Official Transcript of Proceedings
NUCLEAR REGULATORY COMMISSION

Title: Advisory Committee on Reactor Safeguards
AP 1000 Subcommittee: Open Session

Date: Wednesday, October 19, 2011

Switchyard Single-Line Diagram

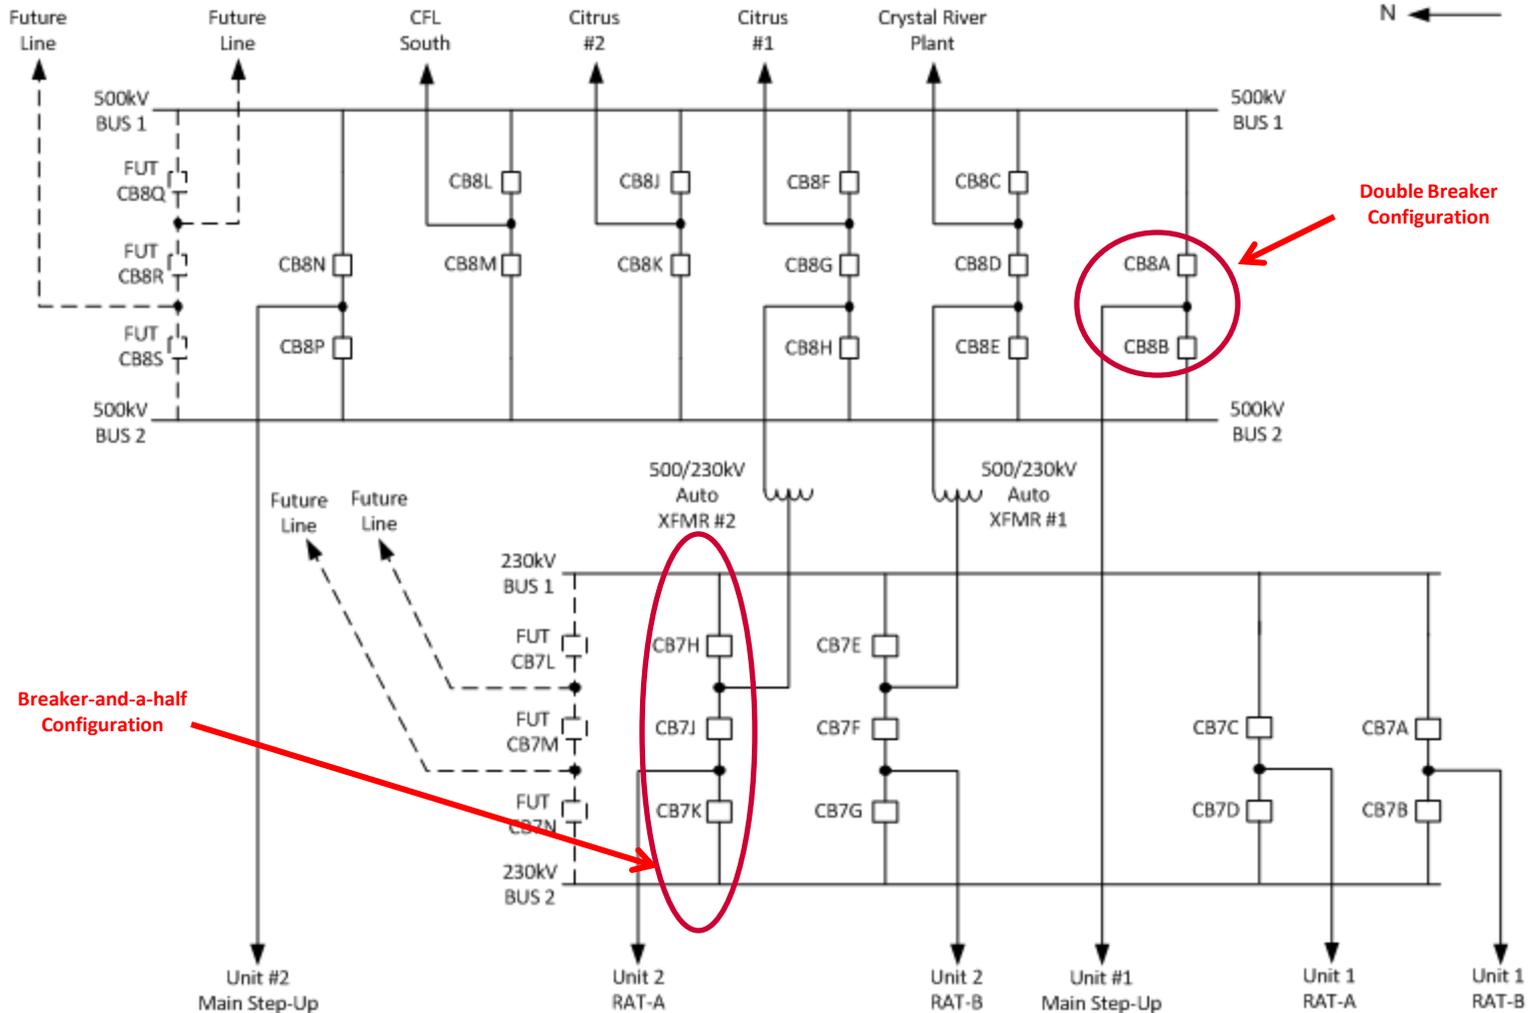
21 MEMBER BROWN: The figure you had in the
22 FSAR conflicts like all the lines come in along the
23 same path. The figure I'm referring to is 8.2-202.
24 And it just shows all the lines coming parallel to
25 each other and then going up into the, seaward's

8 MR. BAKSH: Right, you are correct that
9 the structures are located within a common corridor.
10 Currently the structures are spaced 105 feet apart,
11 center to center. And they are designed such that no
12 one structure has the ability to impact an adjacent
13 structure if an accident were to occur.
